**THE IMPROVEMENTS OF
PROCTOR ROAD
FROM REDWOOD ROAD TO CAMONO ALTA MIRA
CASTRO VALLEY, ALAMRDA COUNTY, CALIFORNIA
SPECIFICATION NO. 2491**

This addendum is issued by the County of Alameda, Public Works Agency, Construction and Development Services Department, 399 Elmhurst Street, Hayward, CA 94544.

Receipt of this Addendum No. 1 must be acknowledged on the form in the bid proposal in writing.

1

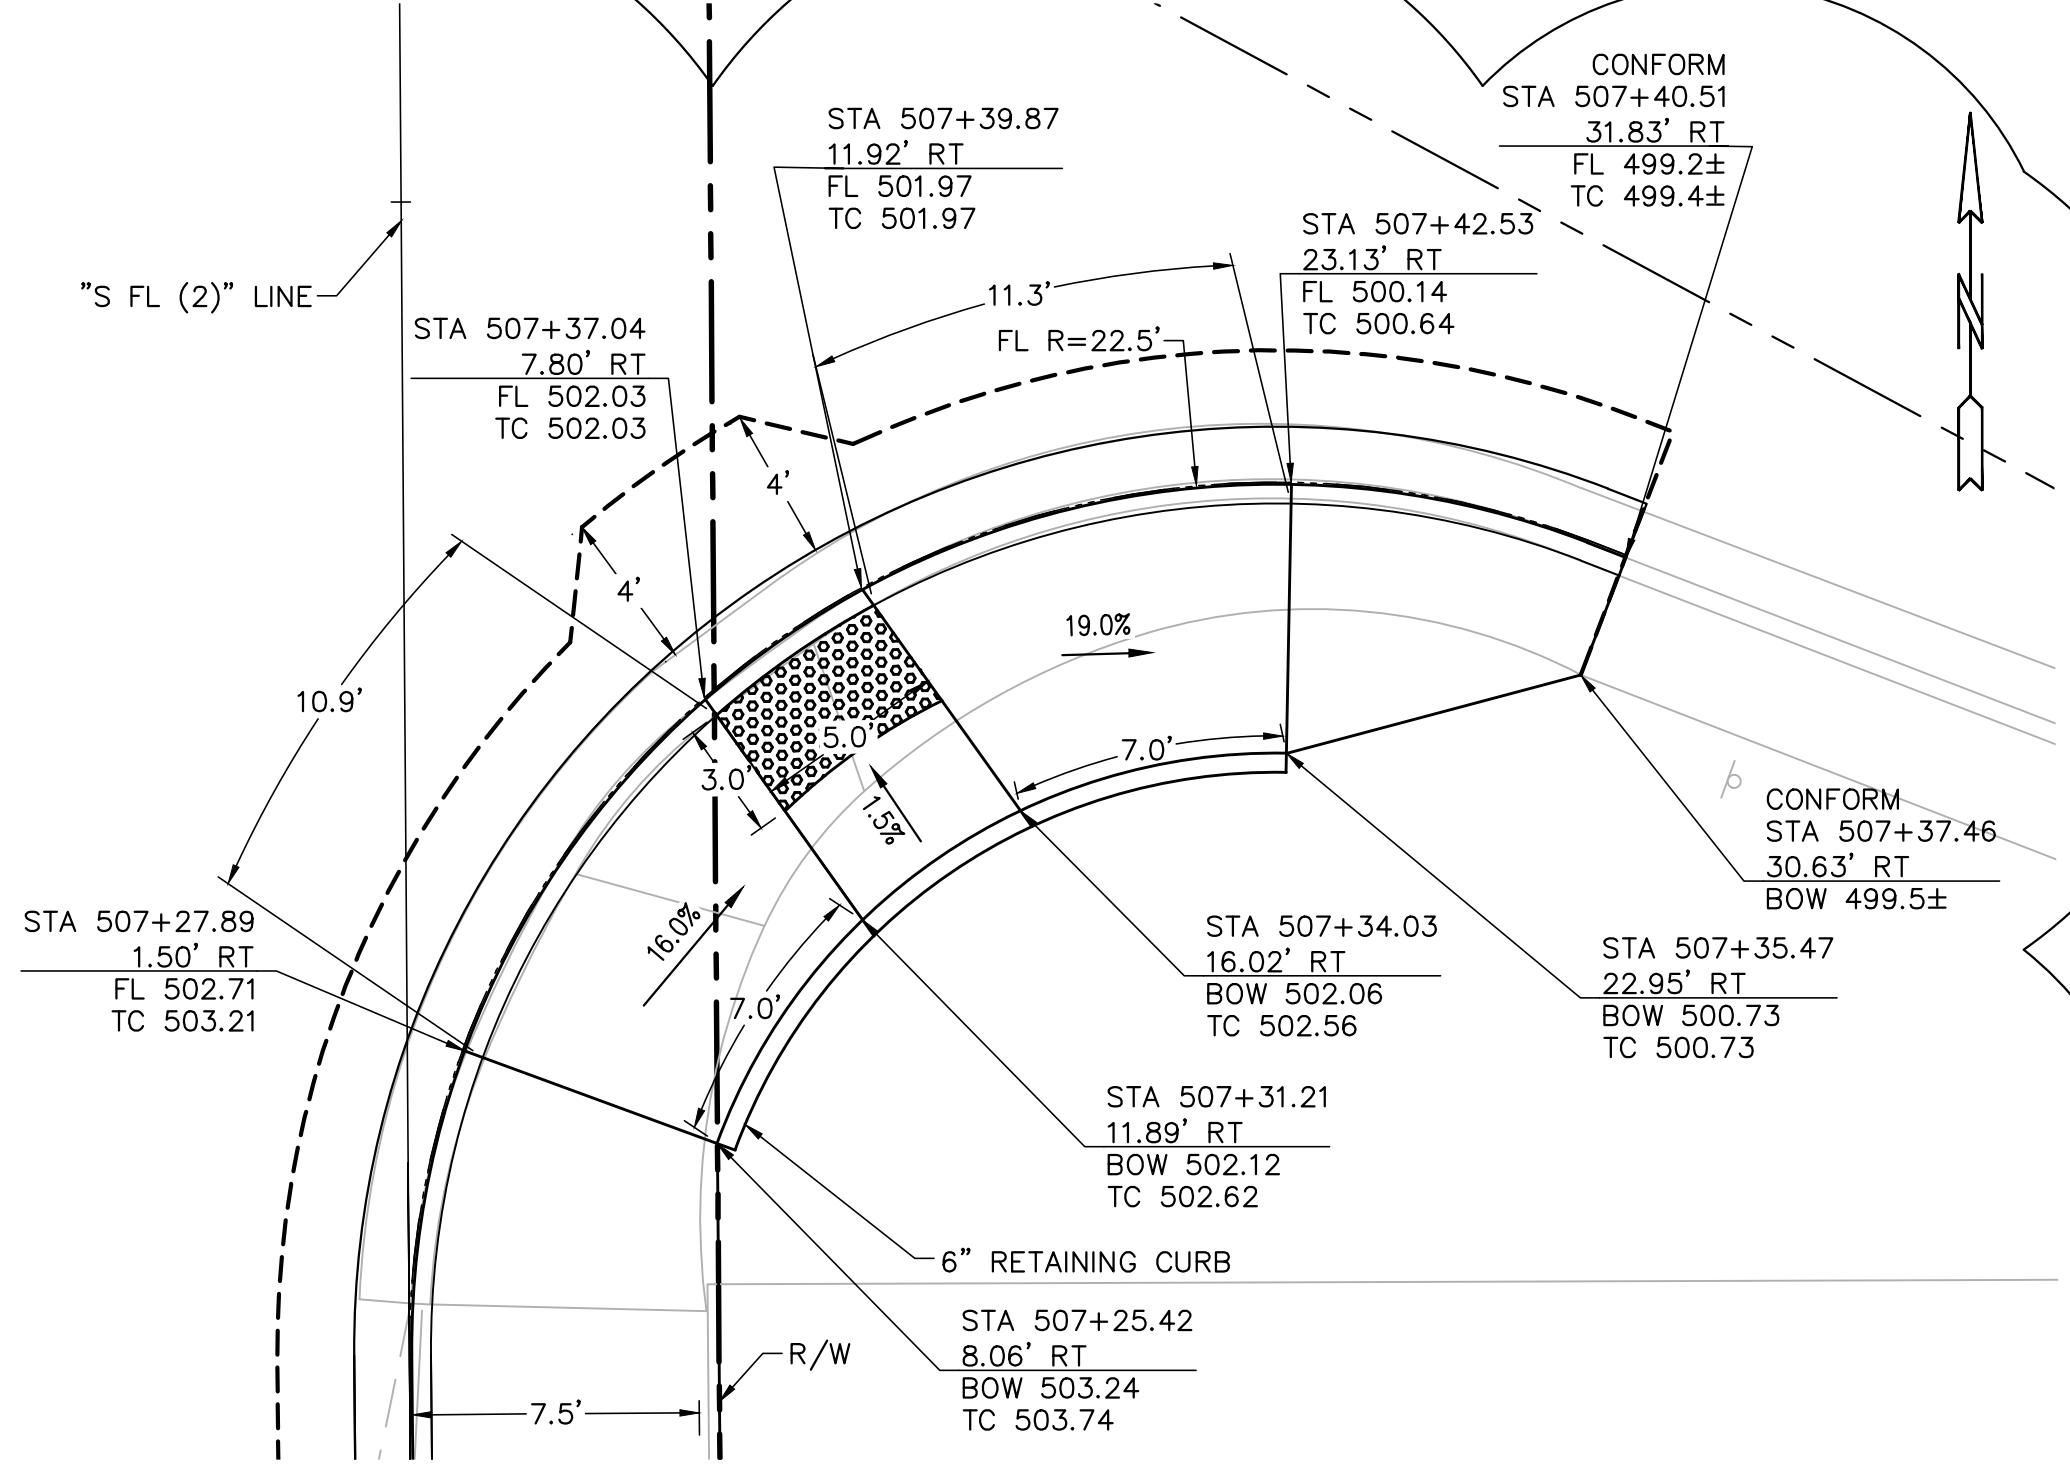
COUNTY OF ALAMEDA ☆ PUBLIC WORKS AGENCY				REVISIONS			
THE IMPROVEMENTS OF PROCTOR ROAD FROM REDWOOD ROAD TO CAMINO ALTA MIRA				NO.	DESCRIPTION	BY	DATE
CONSTRUCTION DETAILS				NO.	REVISD CURB RAMP DETAILS	JK	4/8/25
U-639				NO.	APPROVAL	BY	DATE
DATE: MAR 2025				APPROVAL			
WORK ORDER NO. R32144				APPROVAL			
SPECIFICATION NO. 2491				APPROVAL			
SHEET NO. 38 OF 59				APPROVAL			
FILE NO.				APPROVAL			
U-639				APPROVAL			
REVIEWED: EMANUEL KASERNE				APPROVAL			
DESIGNED: AMBER K. LO				APPROVAL			
DRAWN: JACOBSON KRAVETS				APPROVAL			
CHECKED: CAROLYN DAVIS				APPROVAL			
244 Thomas L. Braylor Way Oakland, California 94612				APPROVAL			
(415) 543-8515				APPROVAL			
PROFESSIONAL ENGINEER JAMES CLEMENTS No. C47157				APPROVAL			
DATE OF CALCULATION				APPROVAL			
APPROVAL DATE: 03-07-25				APPROVAL
